Docket Item #9  
BAR CASE #2005-0228

**ISSUE:** Addition and alterations

**APPLICANT:** Thomas Jeffers by R.B. Adams & Assoc.

**LOCATION:** 211 Franklin Street

**Figure 2 - Rear elevation**

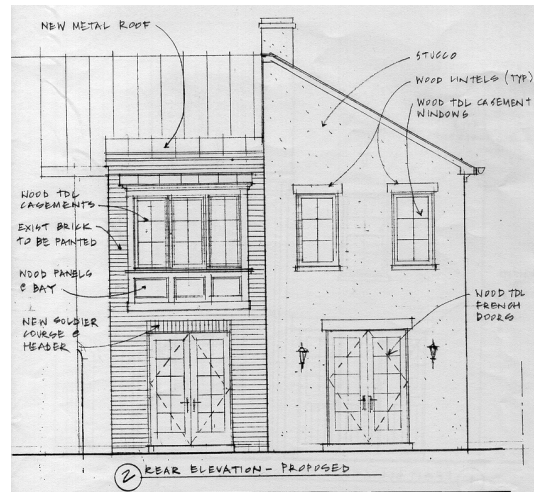
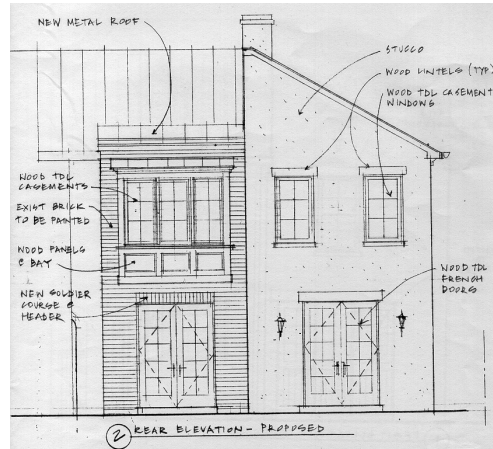
The proposed new openings on the rear elevation of the original house would require removal of a substantial amount of historic fabric (over 55% of the wall area) and would result in a fenestration pattern considerably out of scale with the features and proportions of the original house. Some alteration of these openings may be achievable, but as currently proposed, these changes are not consistent with the *Design Guidelines*.

Staff recommends deferral of the application for restudy to limit the impact of the addition and proposed alterations on the original historic building.

**Figure 3- Side elevation**

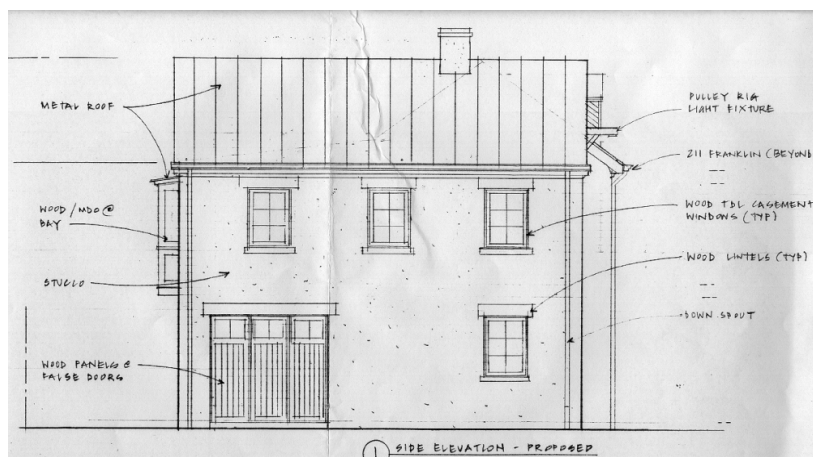
The principal concern with the addition as proposed is the scale and form relationship with the original house. A fundamental precept of additions to historic houses is that of establishing a subordinate relationship between the new and old, a sense of which is lacking in the relationship as proposed. The new flounder makes little if any attempt to mitigate the sharp contrast of form and scale as it abuts and obscures the west wall of the original house, leaving visible to the east, a wide triangular section of wall rising above the gable plane of the house. Although the footprint of the addition is set back 2' from the front wall of the house, it is not sufficient to suggest subordination in this area as well .

The net effect of the addition, despite its own relatively innocuous design and even compatible elements, is to both disregard and then overwhelm the scale, sense of form, integrity and setting of the original house, which renders it thus incompatible with the intent and letter of the guidelines for additions to historic structures. It may be possible to achieve an addition in this location which is more respectful of the original house, but the roof form and its relationship to the house must be revised substantially.
